SUBMITTAL COVERSHEET Nanuet UFSD –Phase 3 Projects

MECHANICAL ROOM HIGH SCHOOL BOILER ROOM COORDINATED SHOP DWG

SAGE LOG NO. M-33

3 MER-STEAM
MP-BM-MER
SCALE: 3/4\"/>

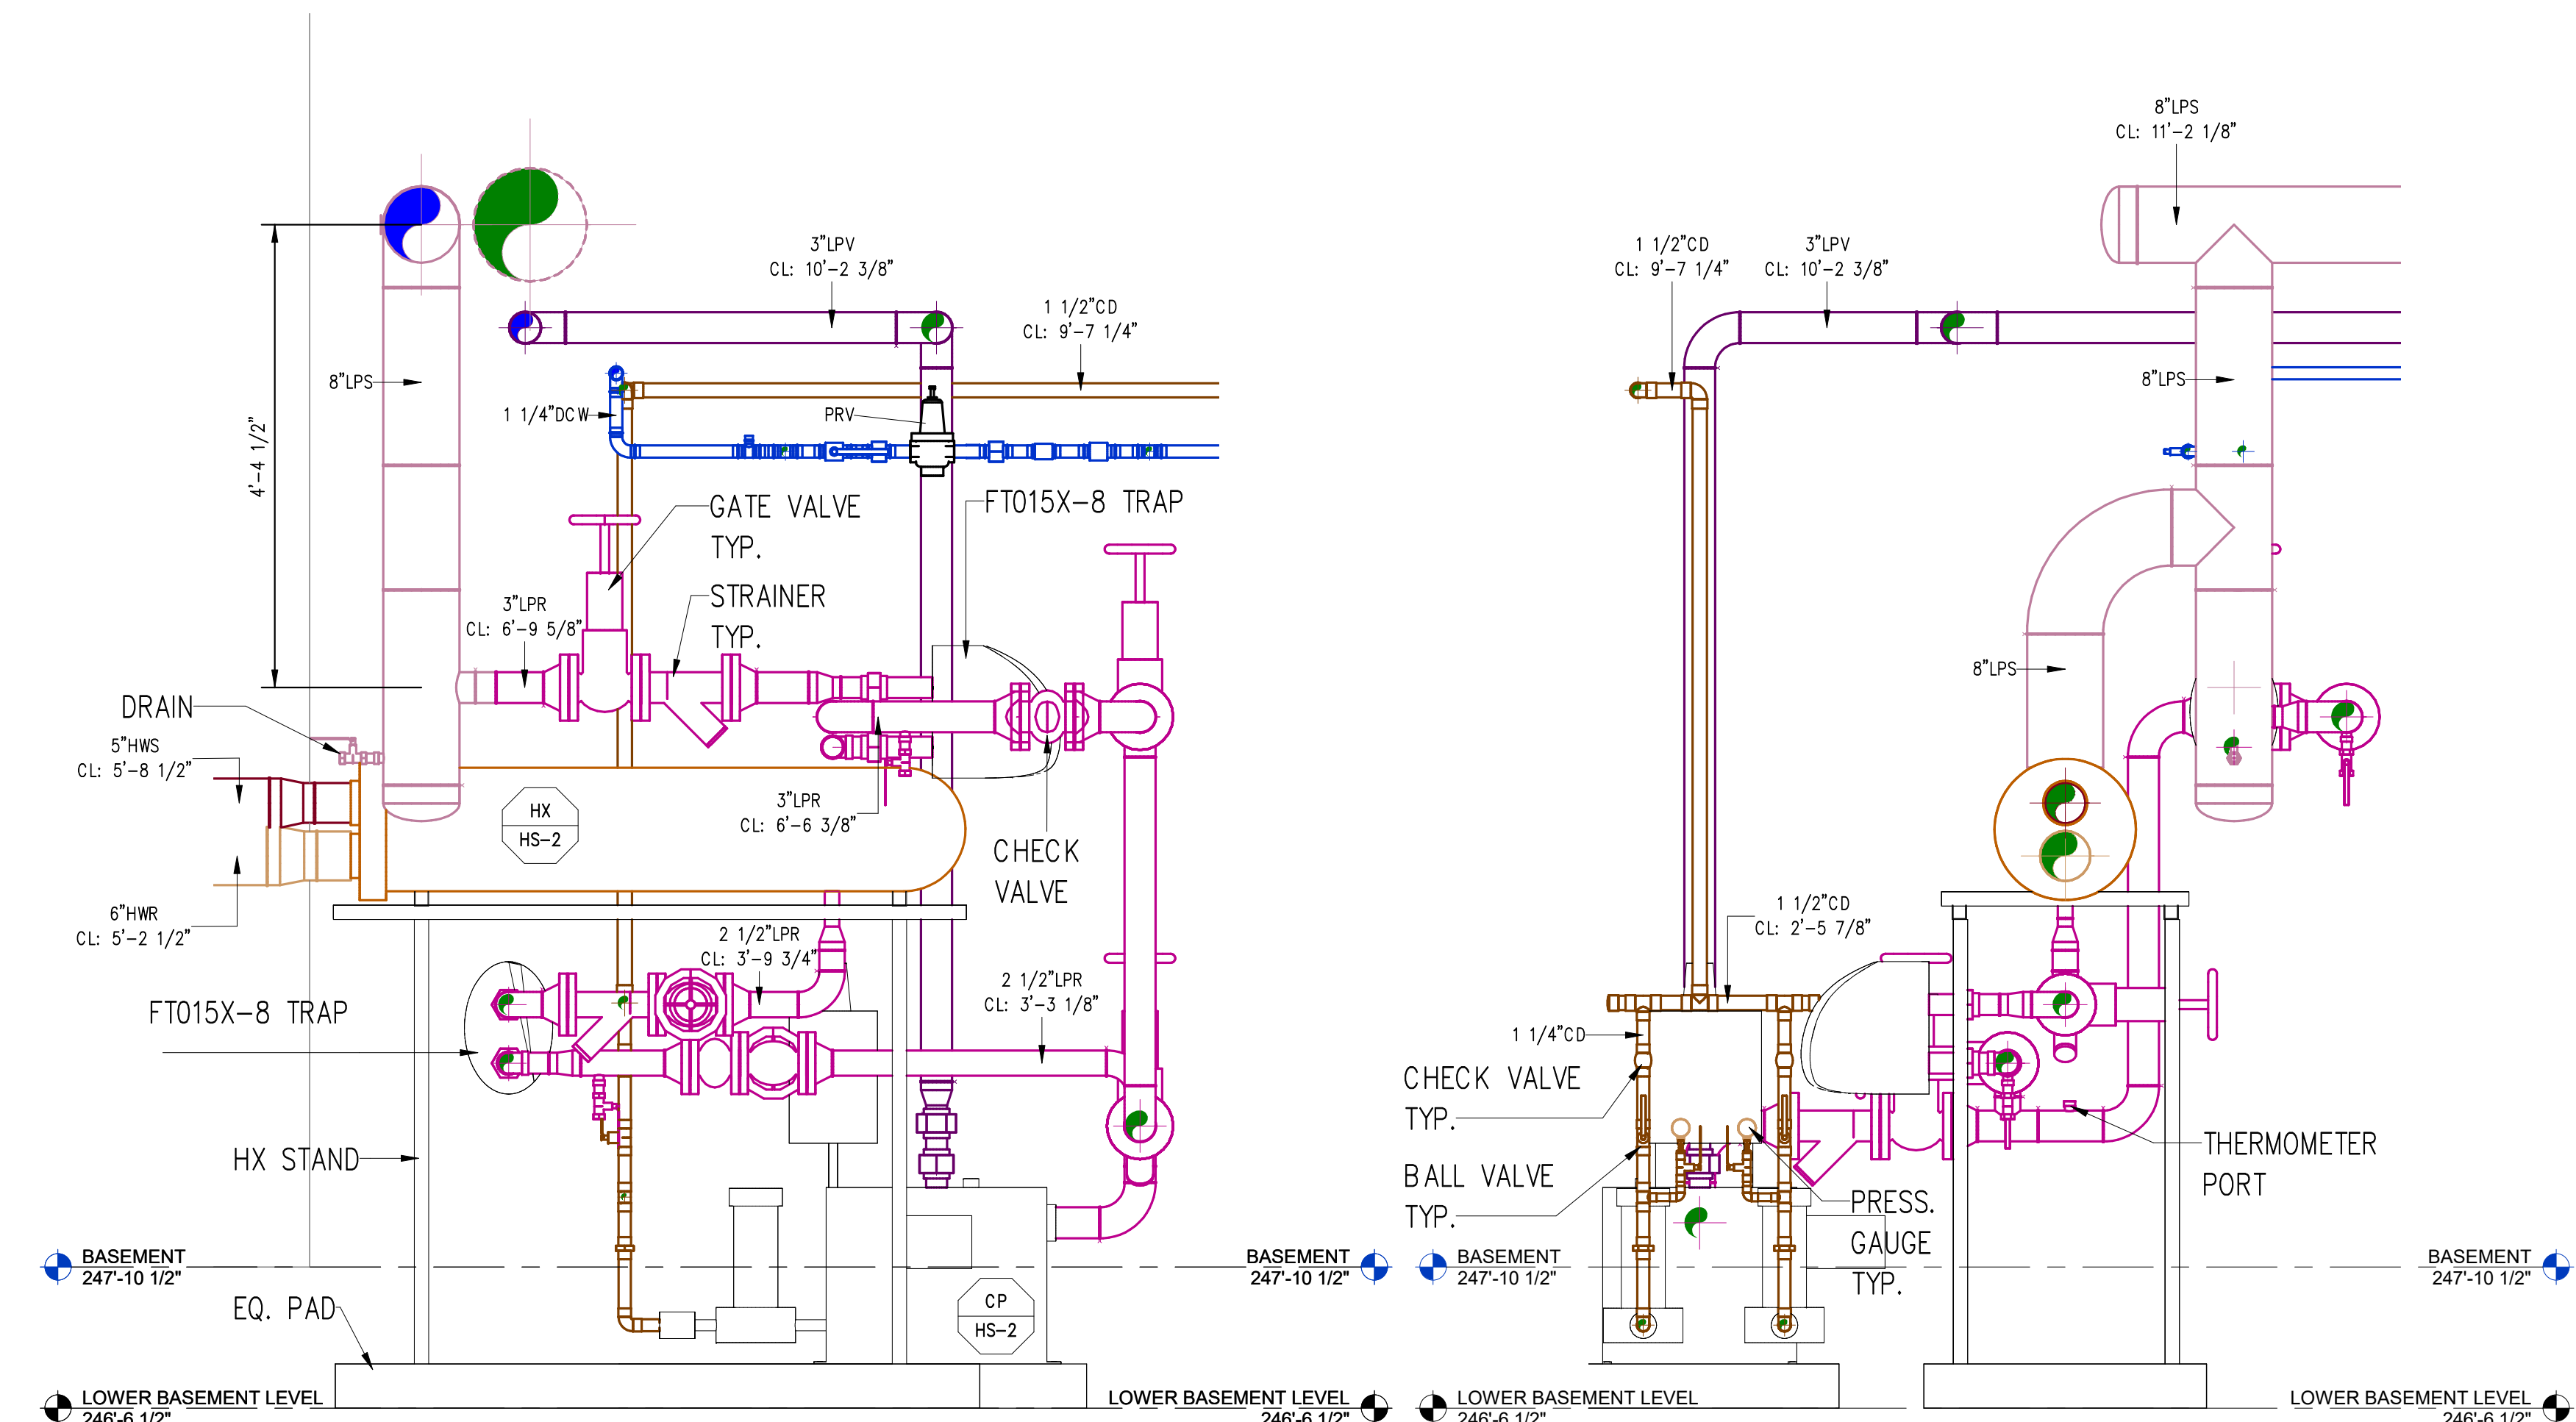
- 1. At the steam main tap, if elevation space allows, provide steam tap at 45 degree angle up to
- avoid the flow of condensate into the branch steam line, then 45 back down to the 11'-2-1/8" CL
- elevation.

If elevation space allows, provide steam tap at 45 degree angle up to avoid the flow of condensate into the branch steam line, then 45 back down to the 11'-2 1/8\"/>
